BMP NUMBER: **PC096**

RE: Files Approved for Scanning

DRAINAGE AND EROSION & SEDIMENT CONTROL PLAN
FORD'S COLONY @ WILLIAMSBURG
SECTION 16-A, LOTS 1-85
OWNER/DEVELOPER: REALTEC INCORPORATED
BERKELEY DISTRICT JAMES CITY COUNTY VIRGINIA

Lot 42, Ford's Colony Section 16-A (193 Heritage Pointe)

PRELIMINARY LAYOUT
LOT 42, SECTION XVI-A, FORD'S COLONY
FOR
WALK WRIGHT CONSTRUCTION L.L.C.
PAGE 2 OF 2
JAMES CITY COUNTY, VIRGINIA

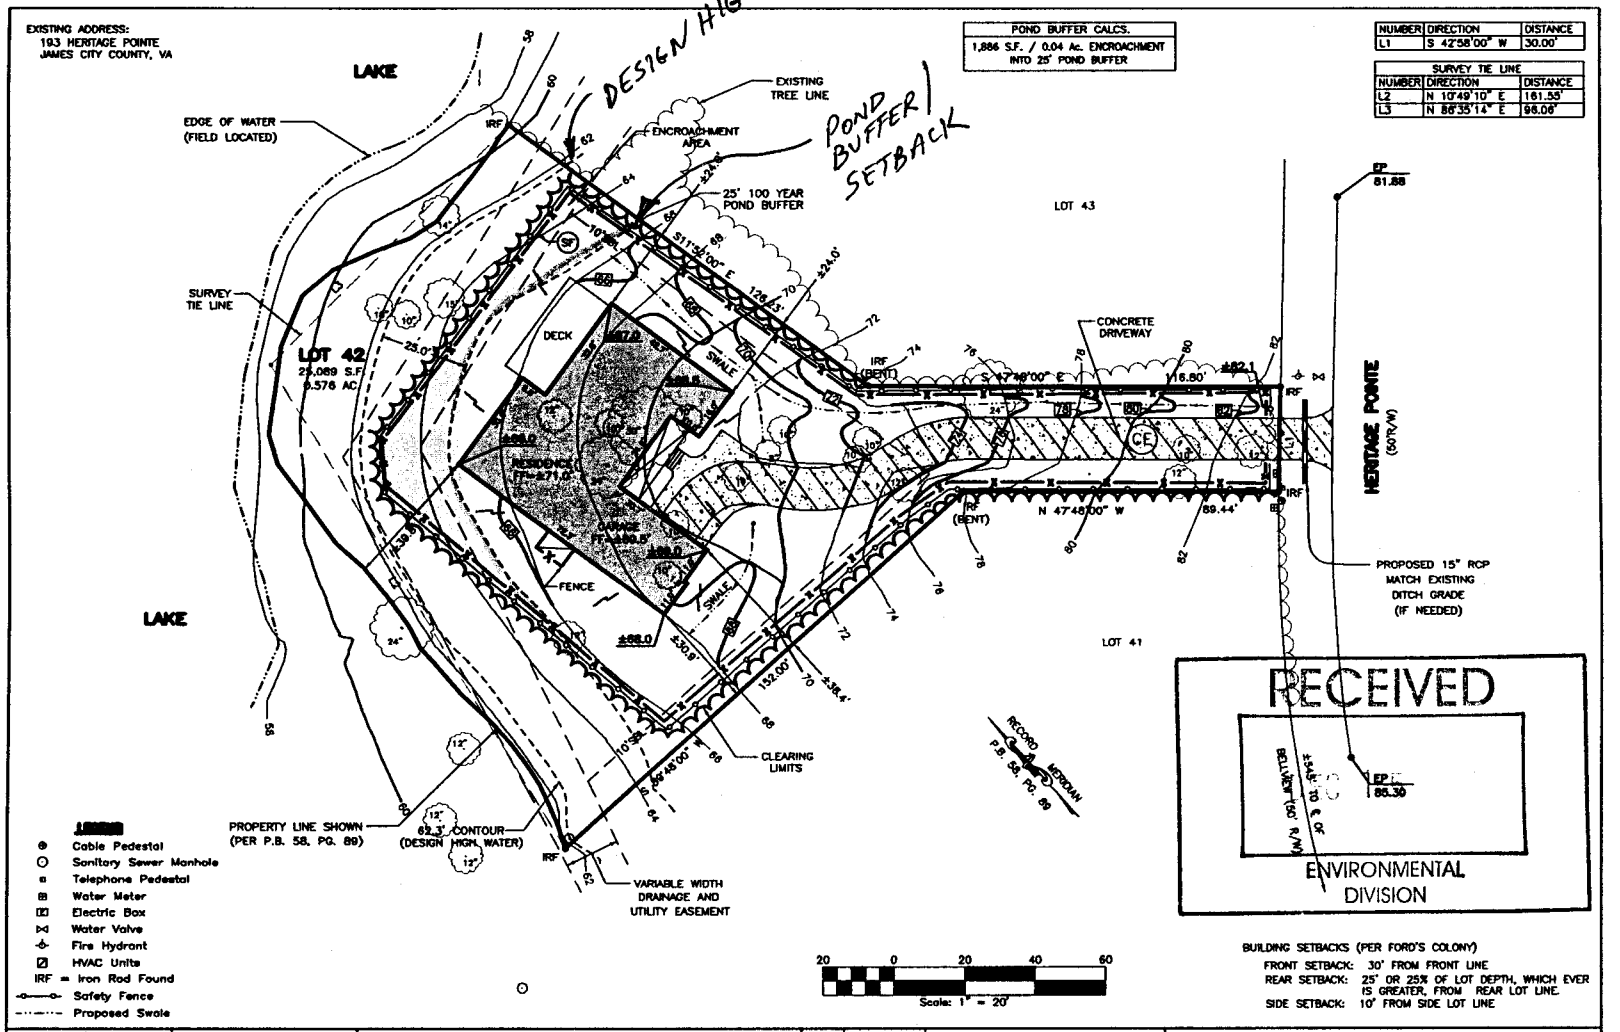
Clearing is shown within the design high water elevation and clearing, grading and permanent structures are proposed within the pond setback/buffer as required per page 38 of the James City County BMP manual. A pond buffer should be provided that extends 25 feet outward from the maximum water surface elevation of the pond. Based on information as available in our record files, it appears the permanent pool elevation and 100-year design high water surface elevation for the adjacent stormwater management facility (Section 16 Lake, County BMP ID Code: PC 096) is at Elevation 59.65 and Elevation 62.3, respectively.

Show the correct location of design high water elevation (El. 62.3) and the pond buffer setback, ensuring that site topography and spot elevations are correctly tied to associated lake elevations. Reconfigure the plan to avoid disturbance to design high water and pond buffer/setback locations; or alternatively, submit a written request for waiver to the Environmental Division to impact design high water and/or the pond buffer setback. Supporting information shall include: correct delineation of the design high water and 25 ft. buffer/setback on the single-family plan; acknowledgment from the owner/tenant; proposed horizontal and vertical separations from the structure to design high water. If filling design high water, then provide an engineering analyses that the proposed lot fill material will have no adverse impact on the storage volume or function of the stormwater management facility.

The variance request needs to be from the owner or tenant, current or future, rather than the builder contractor. Efforts should be made to preserve existing trees and vegetation in the buffer during construction and to stabilize or landscape disturbed buffer area back to meadow or forest condition using native trees, shrubs or ground cover to the greatest extent possible.

Variance request as submitted by Owner dated December 13, 2006 for clearing in the pond buffer/setback was reviewed and found to be acceptable. Efforts should be made to preserve existing trees and vegetation in the buffer during construction, to landscape or stabilize impacted buffer to resemble meadow or forest area with native trees, shrubs and ground cover, and to refrain from turfing to the water's edge to the greatest extent possible.
